CONVAIR

COMMERCIAL CHANGE PROPOSAL

SPEC NO.: ZD-22-327 DATE: _____
 CUSTOMER: JAL MCL 15,037 DTD _____
 CHANGE NO: 93 MODEL: 22-3 (22M)

TITLE: Specification Administrative Change (Revision to Portable Oxygen Bottle Part Number - Group C Airplanes)

Page 50a - PITOT STATIC SYSTEM - ILLUSTRATION:

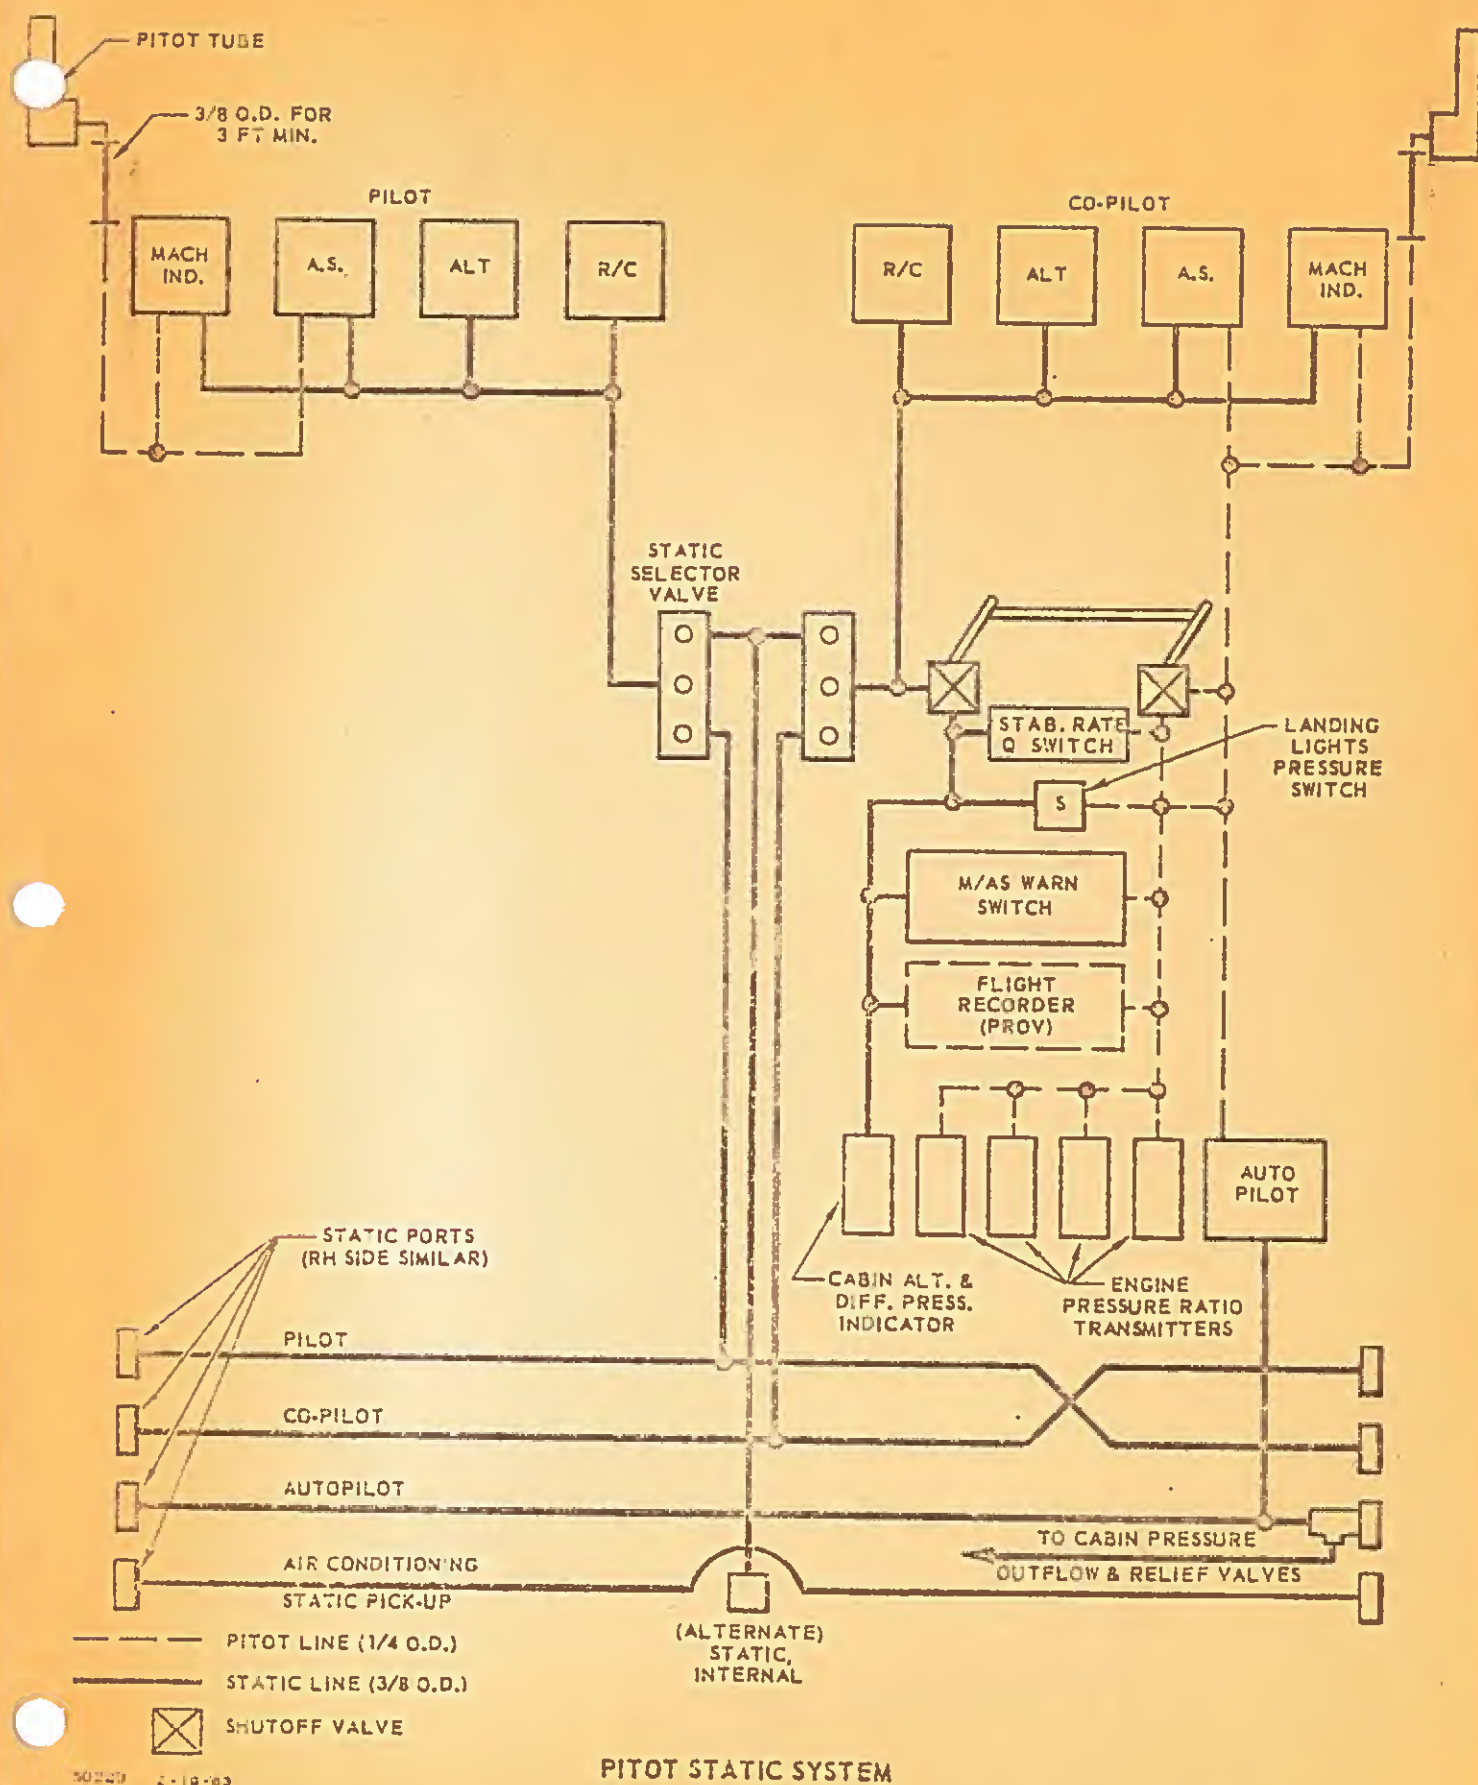
Reason for Change: To up-date pitot static system to show separation of static sources for cabin outflow valves and cabin controller.

Replace above illustration in the specification with attached revised illustration to show current changes.

Page 46a - PITOT STATIC SYSTEM - ILLUSTRATION:

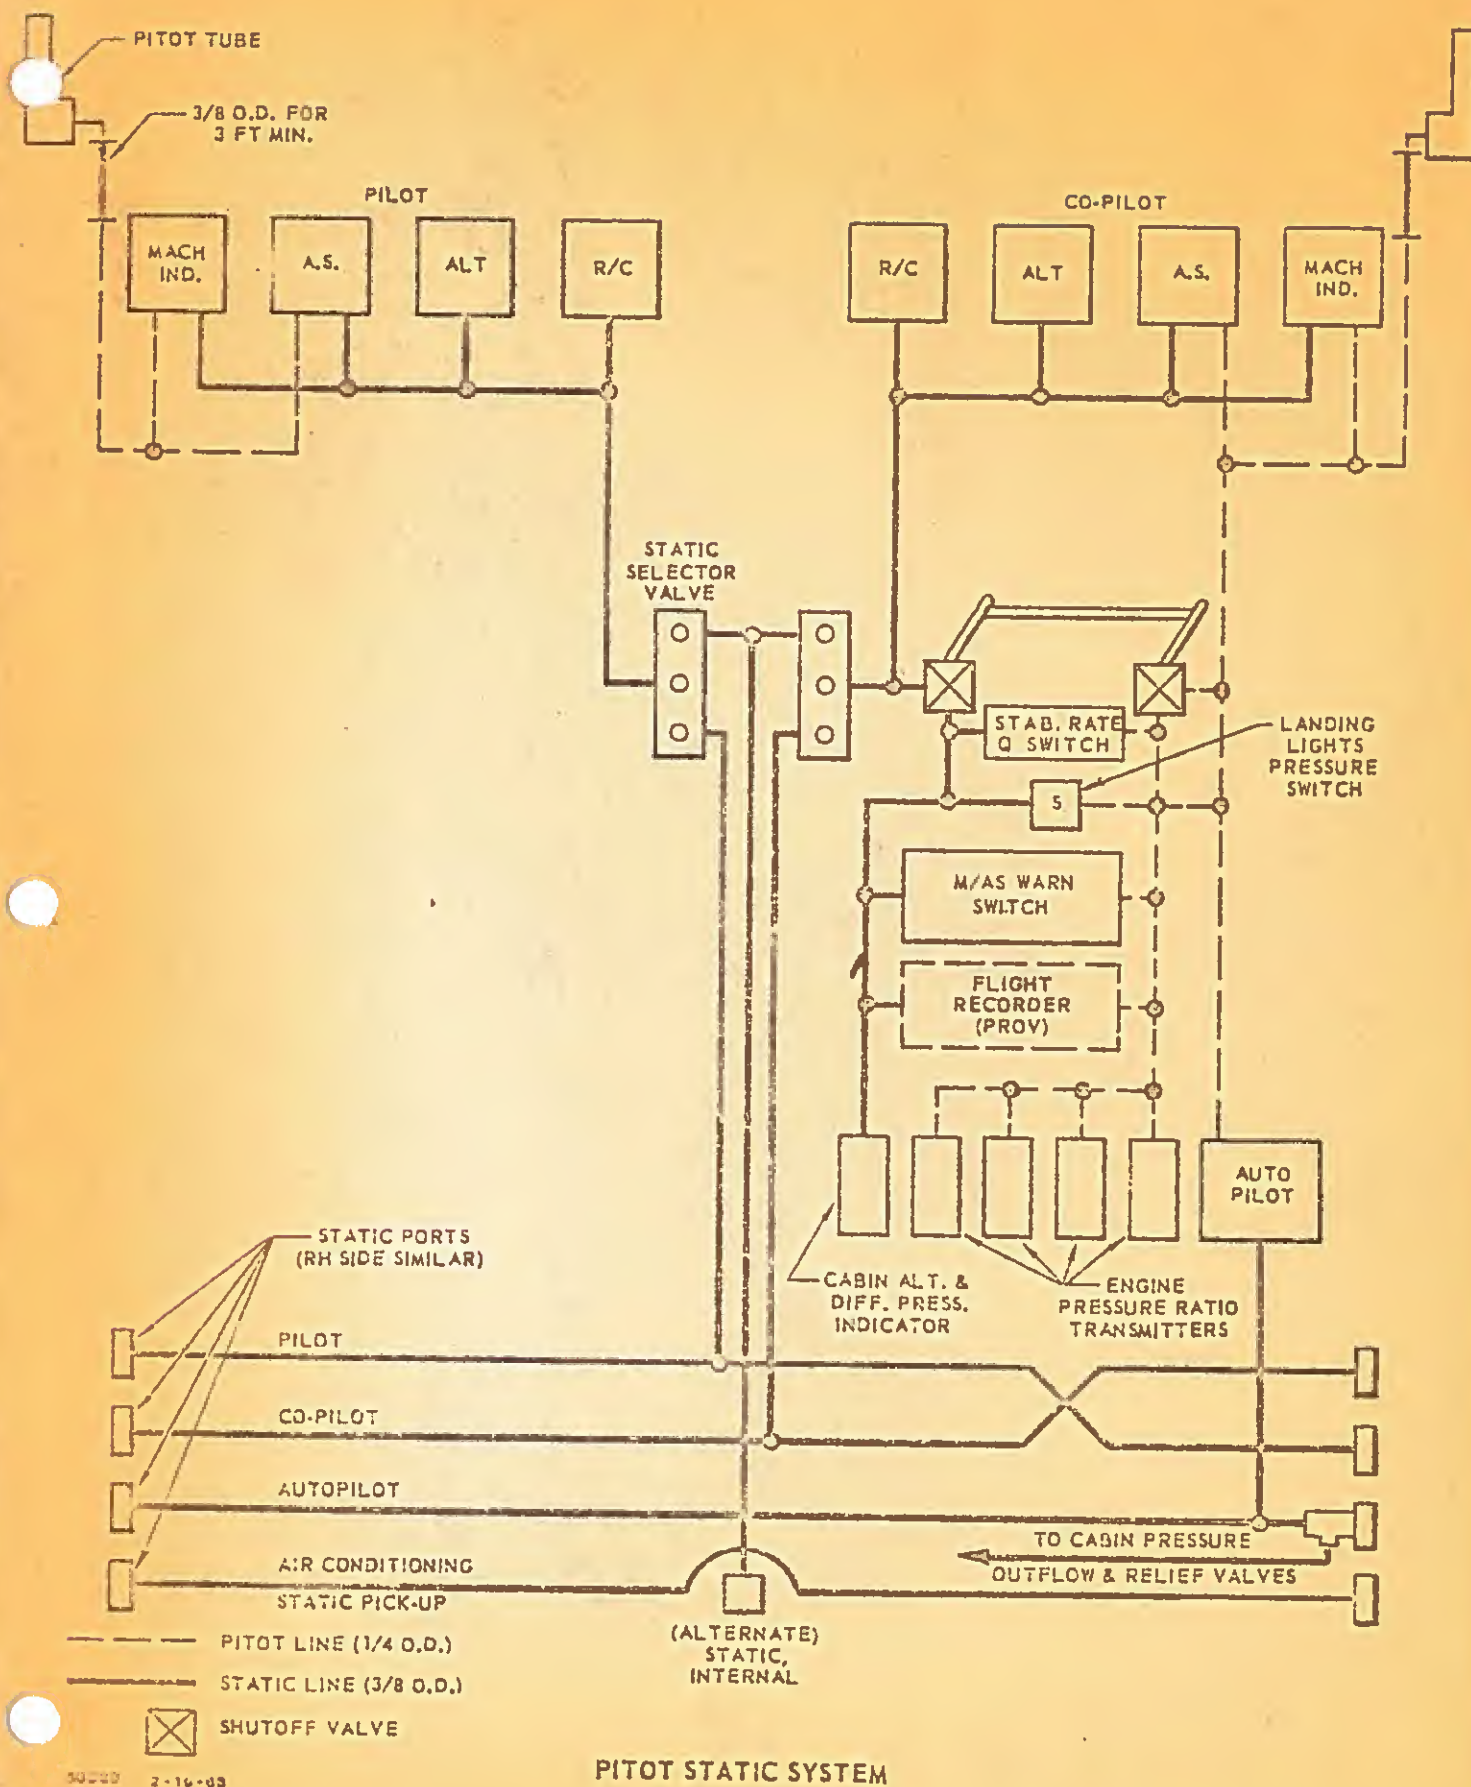
Reason for Change: To up-date pitot static system to show separation of static sources for cabin outflow valves and cabin controller.

Replace above illustration in the specification with attached revised illustration to show current changes.

PILOT'S AND COPILOT'S INSTRUMENT PANELS

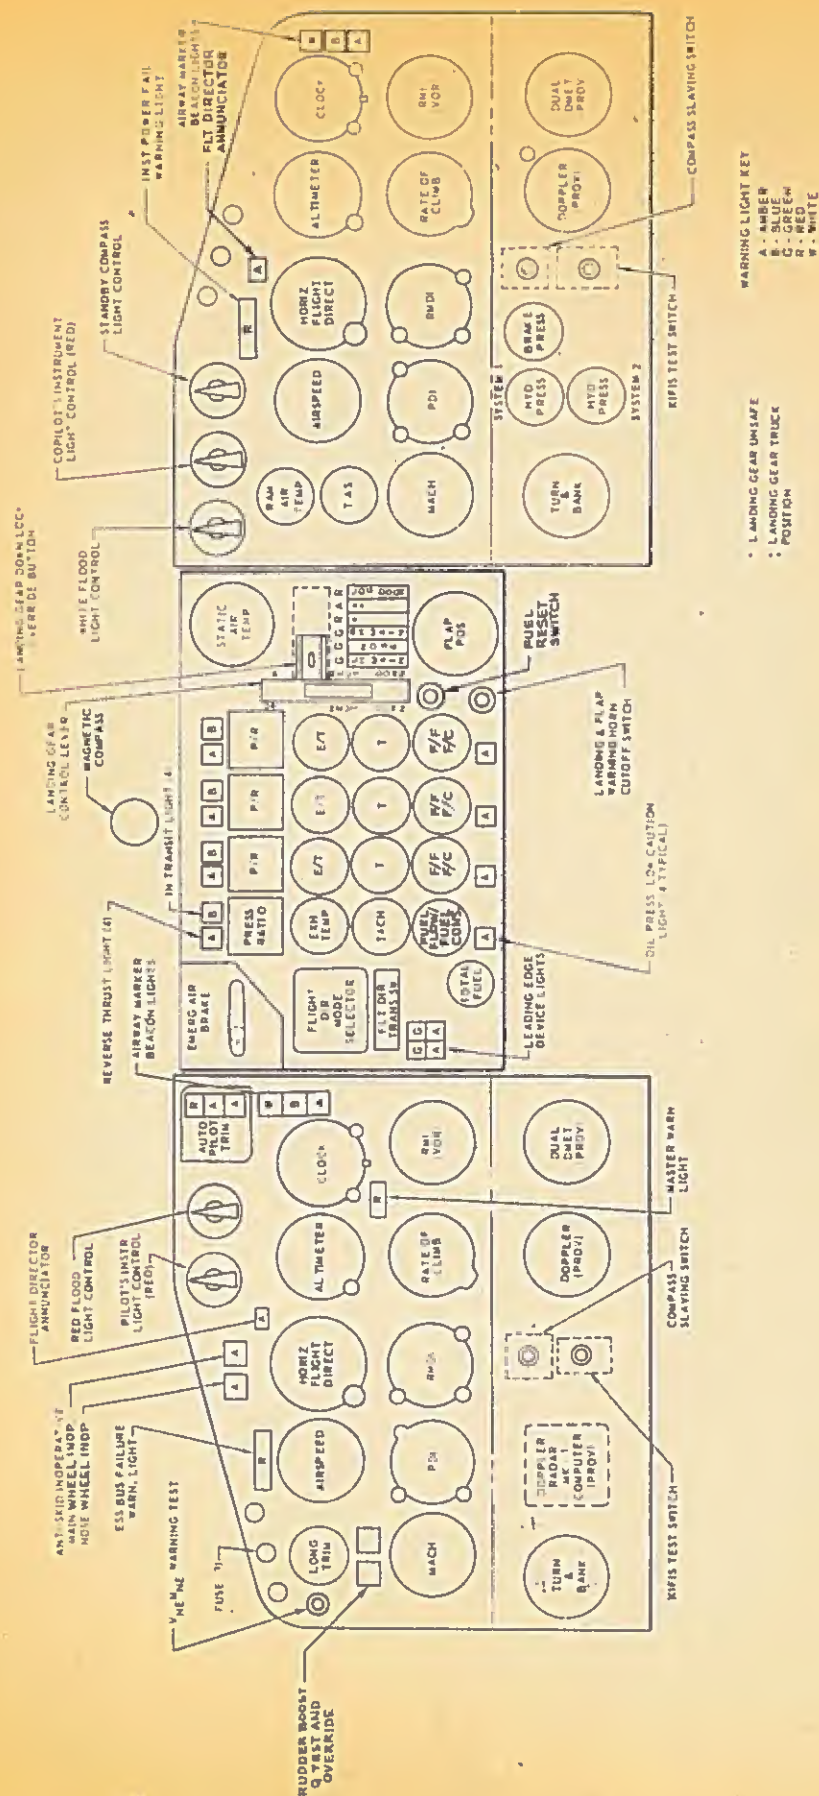
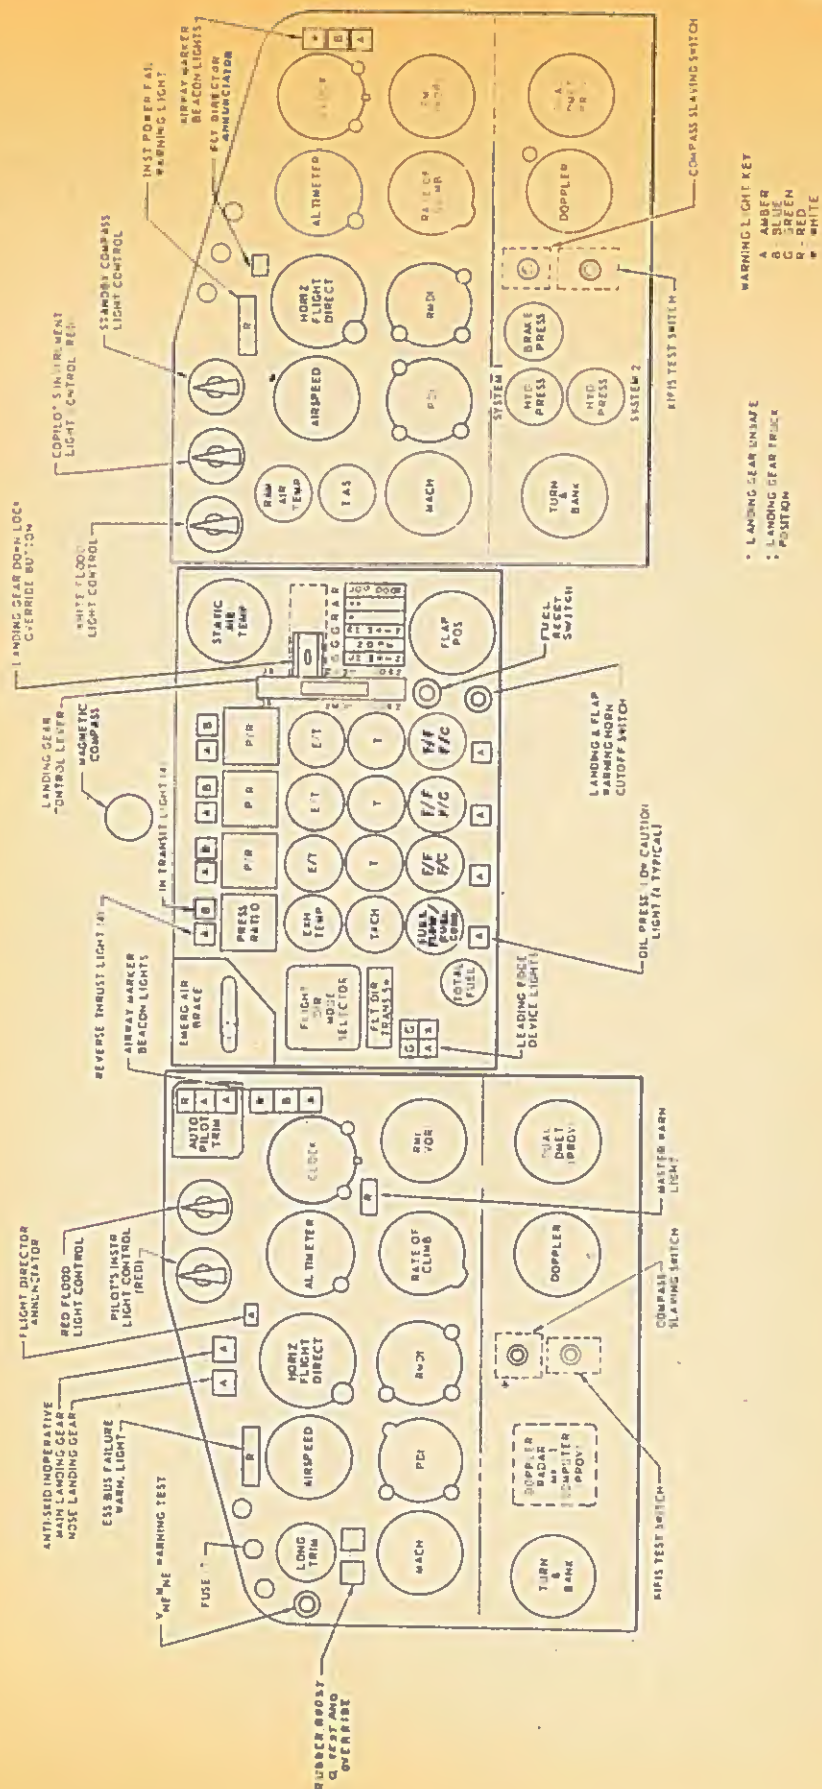
Revise above illustration to show ship effectivity 1, 2 and 3.

Add the above illustration which shall show ship effectivity 4 and 5, and the installation of Doppler indicator.
